Project	IEEE 802.16 Broadband Wireless Access Working Group < <a href="http://ieee802.org/16">http://ieee802.org/16</a> >	
Title	Problems with DBPC Messages and a Solution	
Date Submitted	2005-01-13	
Source(s)	<p>David A Castelow, Gavin Meakes, Eyal Verbin</p> <p>Airspan Communications, Cambridge House, Oxford Road, Uxbridge, UK</p> <p>Rainer Ullmann, Donald Stevenson</p> <p>Wavesat Inc 1375 Trans-Canada Highway Suit 300 Dorval, Quebec H9P 2W8 Canada</p>	<p>Voice: +44 1895 467281 Fax: +44 1895 467202 <a href="mailto:dcastelow@airspan.com">mailto:dcastelow@airspan.com</a></p> <p><a href="mailto:rullmann@wavesat.com">mailto:rullmann@wavesat.com</a></p>
Re:	Supporting document for Comment 612 and Reply to Comment 084 (802.16-04/04r9)	
Abstract	Changes required in order to enable good operation of 802.16 systems.	
Purpose	The document is intended for consideration within the comments resolution process.

# Problems with DBPC Messages and a Solution

**Figure 79—Transition to a more robust burst profile**

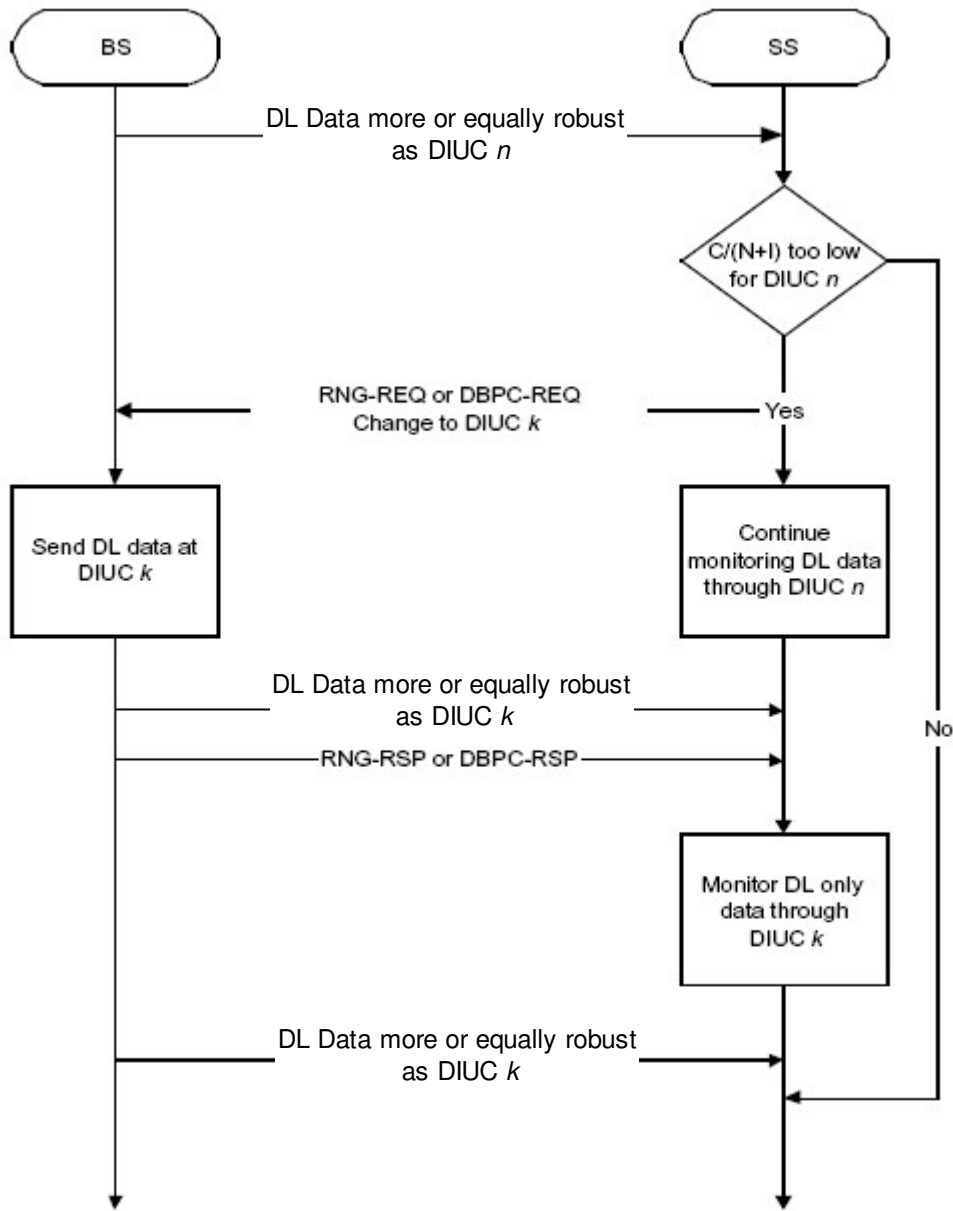
Page 203: Figure 79 needs to indicate action of SS in event of non-detection of DBPC-RSP.

Also DL data may be on DIUC up to m, not at m. This requires a change to Figure 79 also.

Change Figure 79 as indicated:

**Figure 80—Transition to a less robust burst profile**

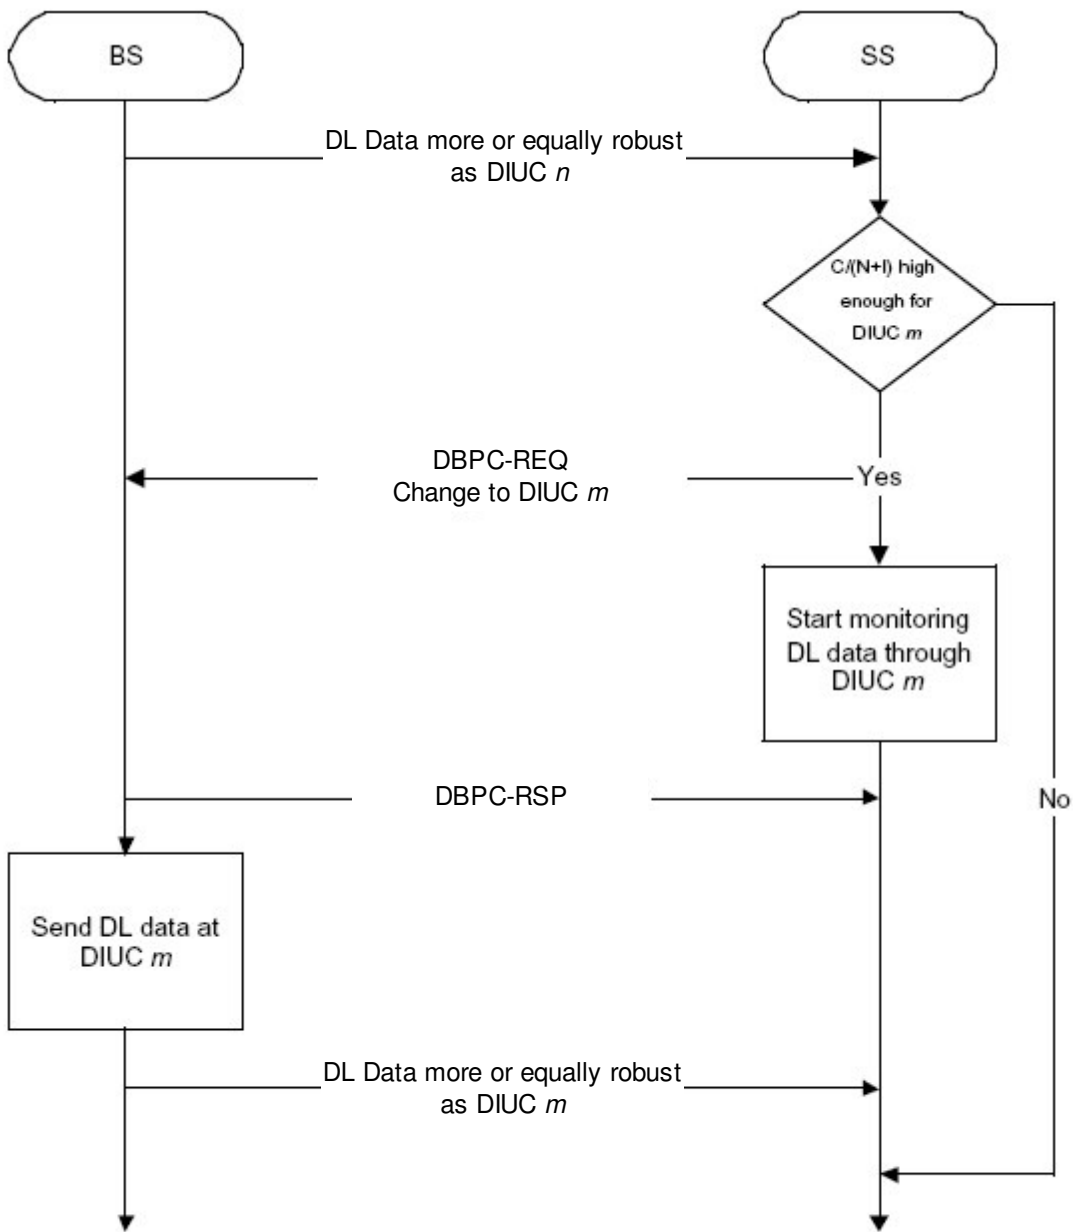
Page 204: Figure 80 needs to indicate action of SS in the event of the BS refusing the DBPC-REQ to move to a less robust modulation.

Change Figure 80 as indicated, as RNG-REQ only to be used for transition to more robust cases when no grant is available (see 6.3.10.1).

Figure 80a – State transition diagram for downlink burst profile management – SS

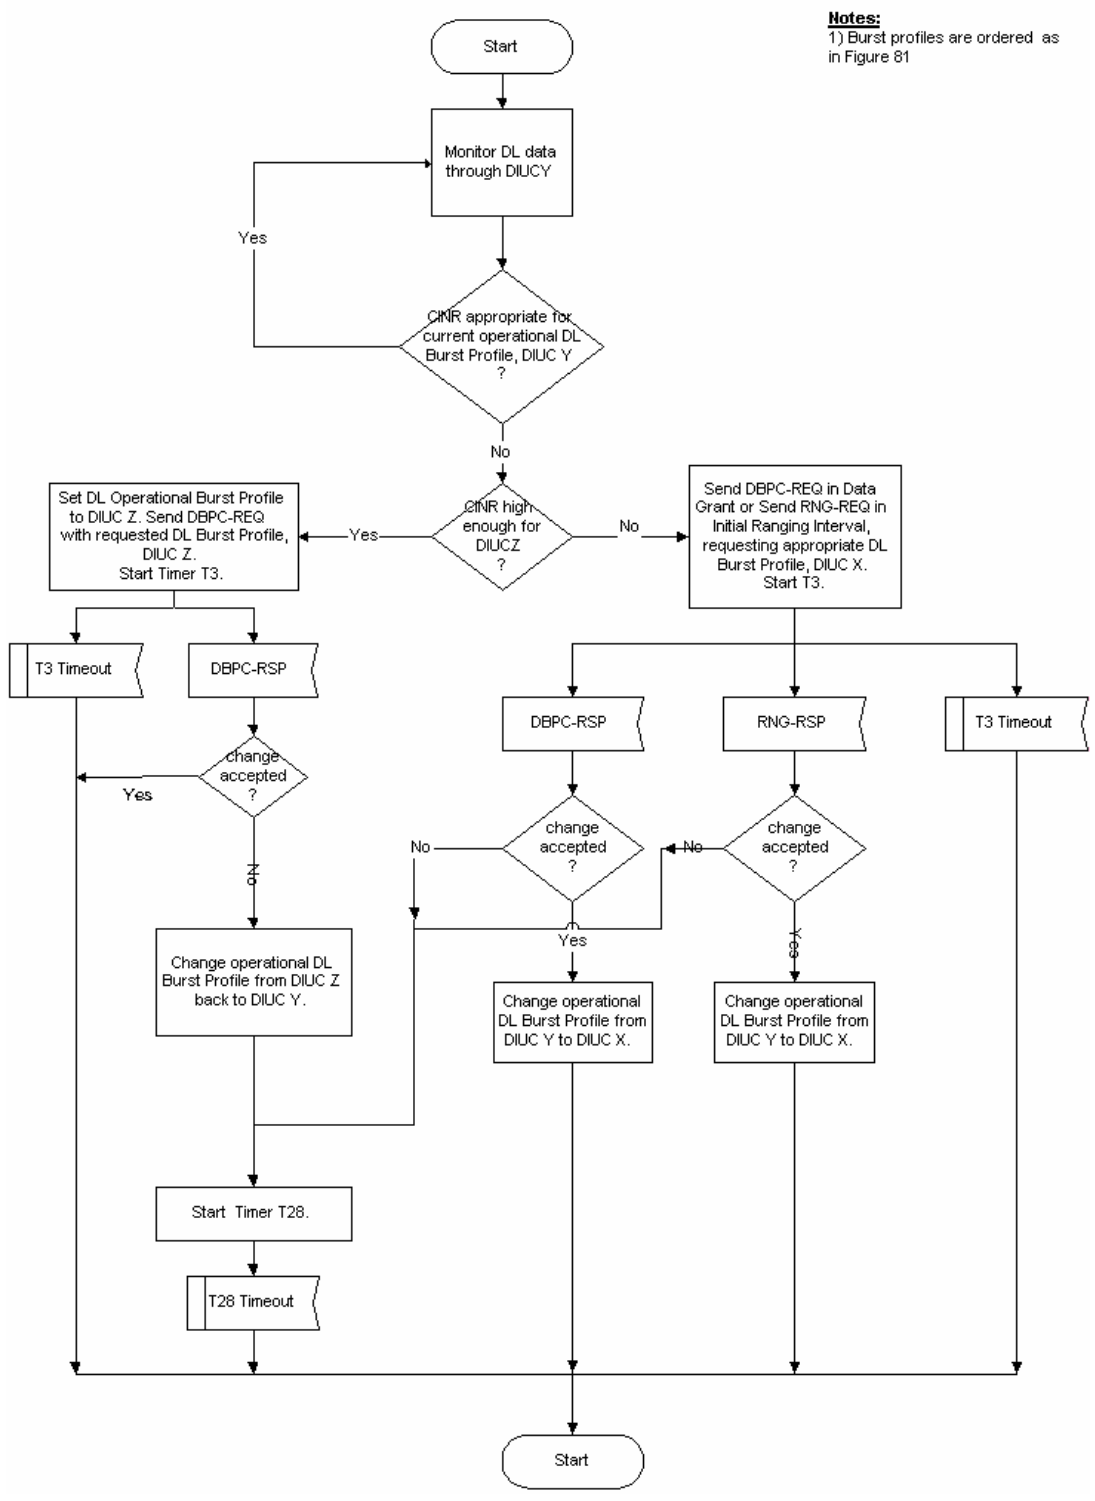
State transition diagrams are needed here, so rather than complicate these diagrams, we introduce a separate figure. This diagram requires timers, so that the BS is not flooded with requests. The diagram (Figure 80a) indicates the actions for the SS, and includes a new timer (T28).

Insert new Figure 80a (see end of contribution).
